BLOCK 17

BASEMENT PLAN

ROYAL PINE HOMES - 218094
921 BAYVIEW, RICHMOND HILL, ON.

GROUND FLOOR PLAN

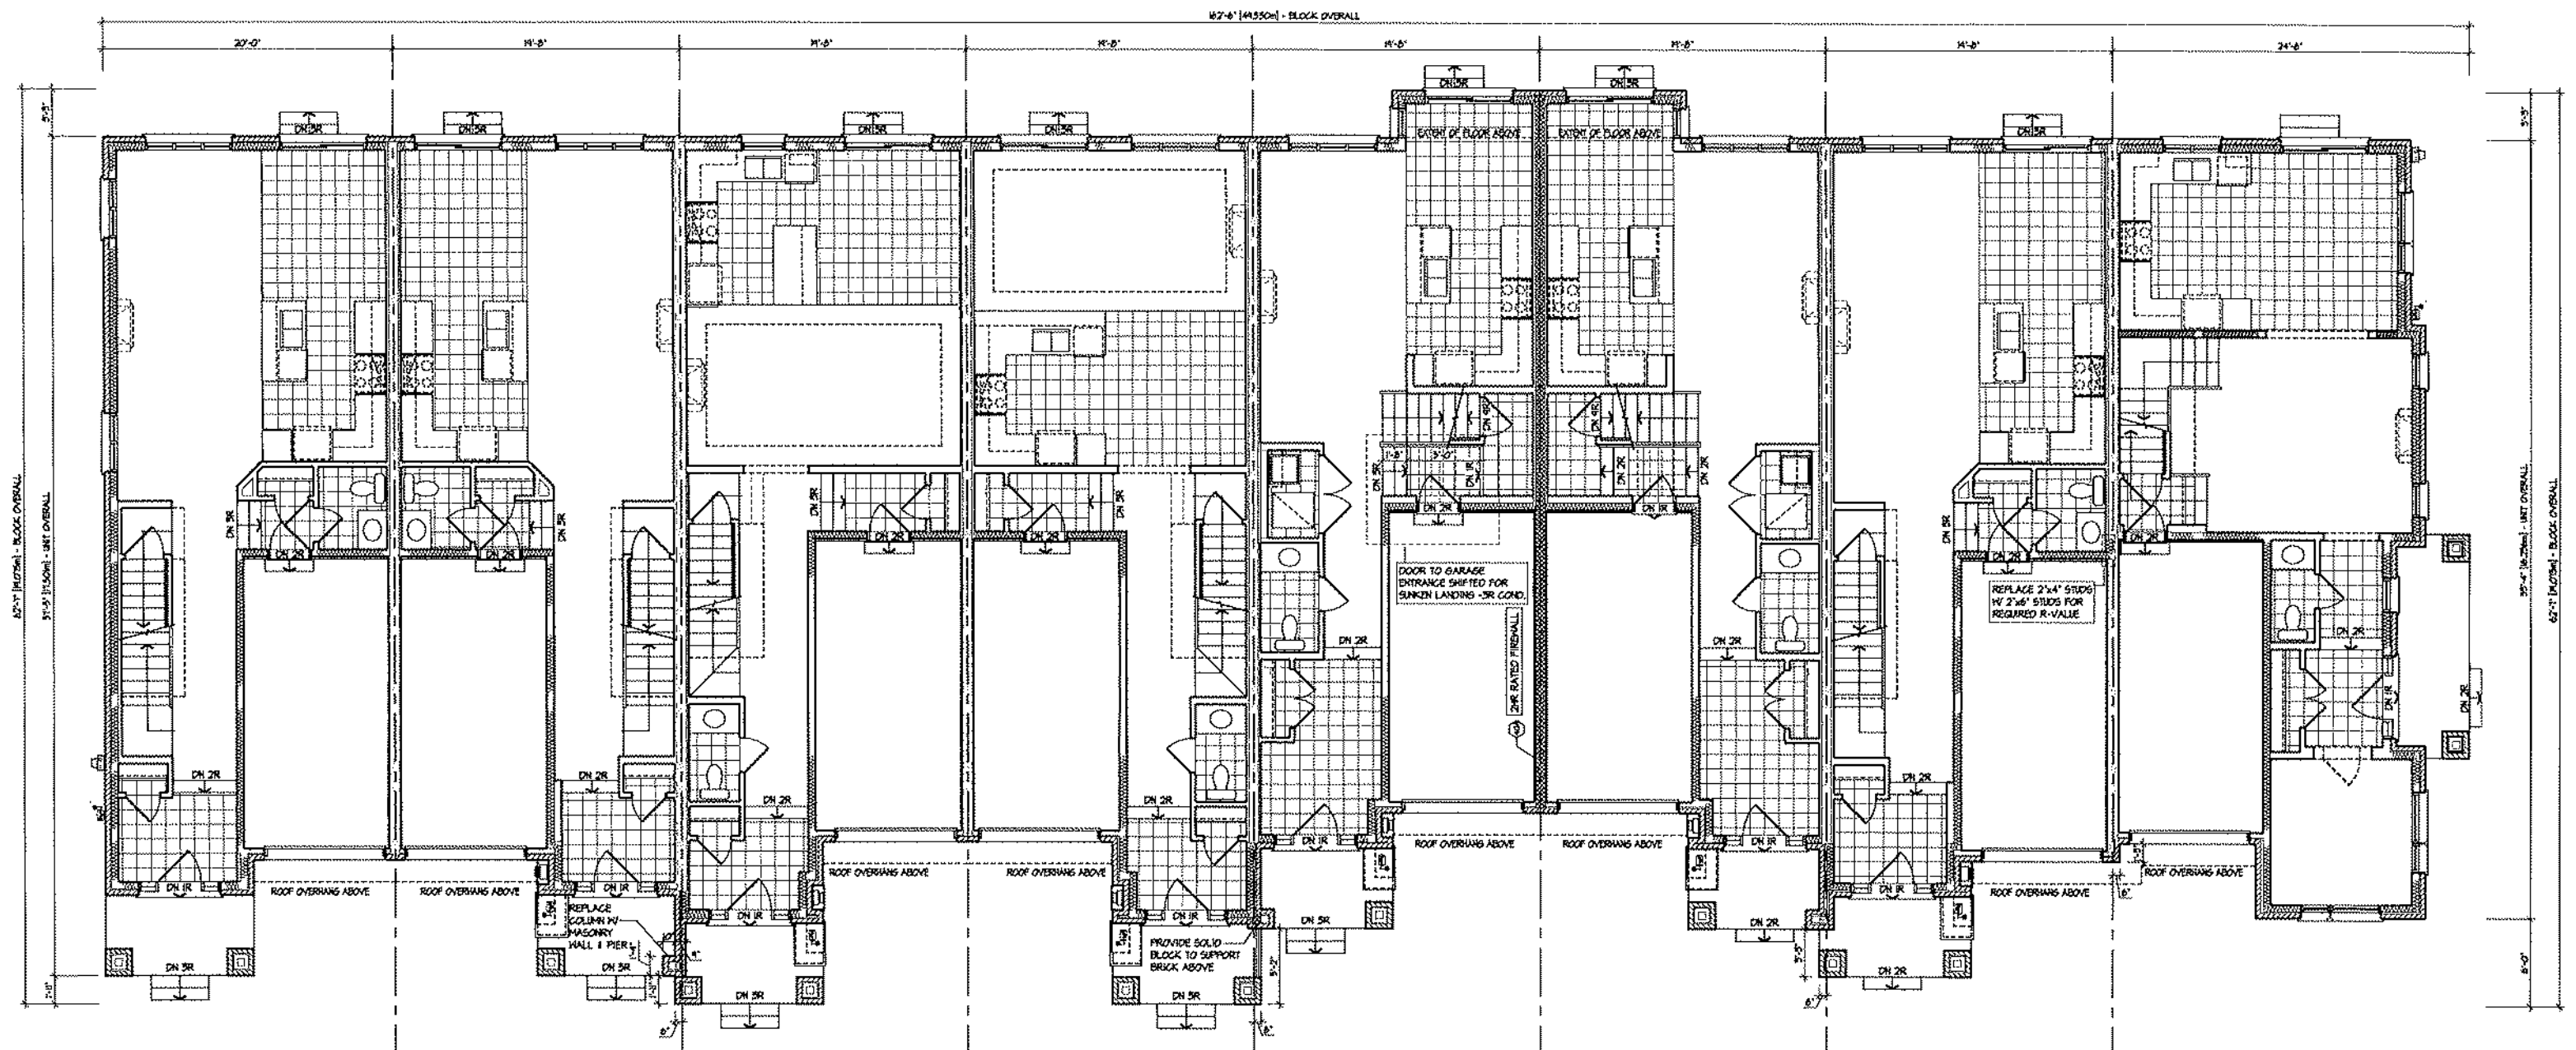
(Handwritten notes in red ink are present in the original image, including "NOT CORRECT" near Unit 2017 and "PLAN 2E" near Unit 2020.)

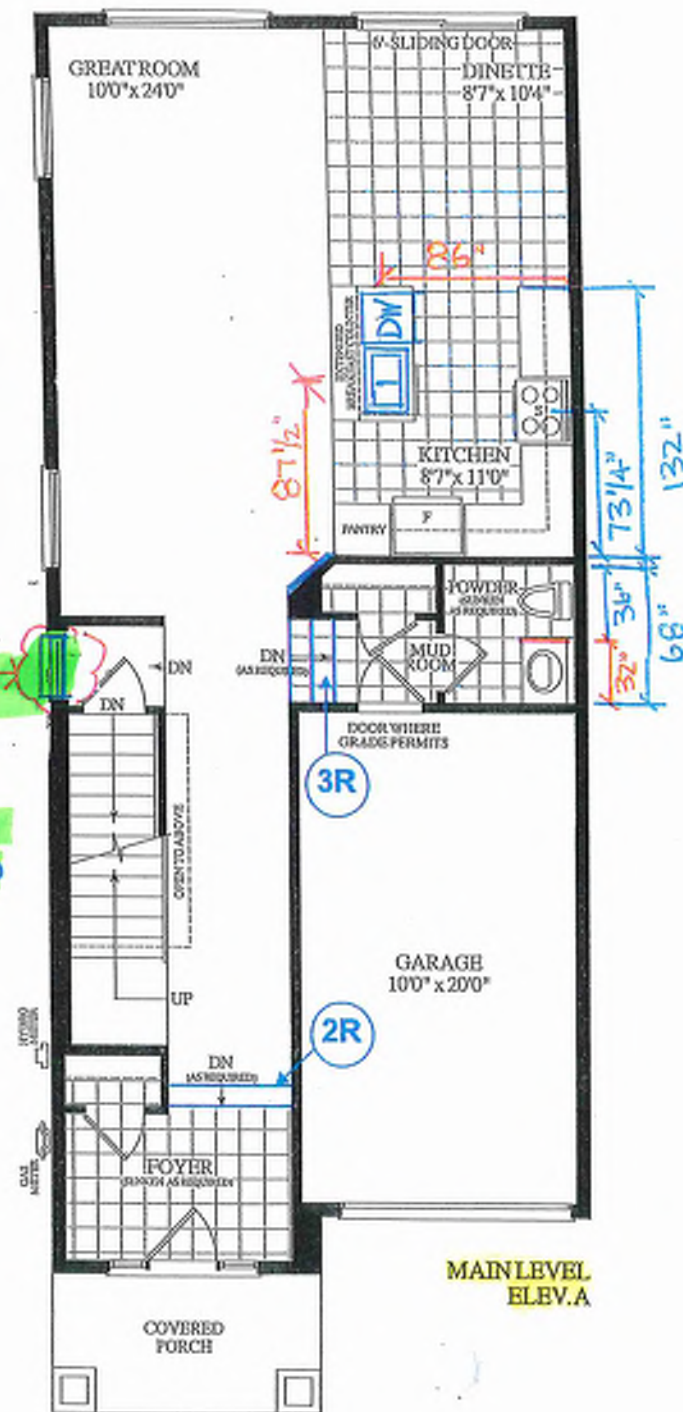
Install
24'x48" Window
CR IN FOR
FUTURE
SIDE DOOR
35'x83"
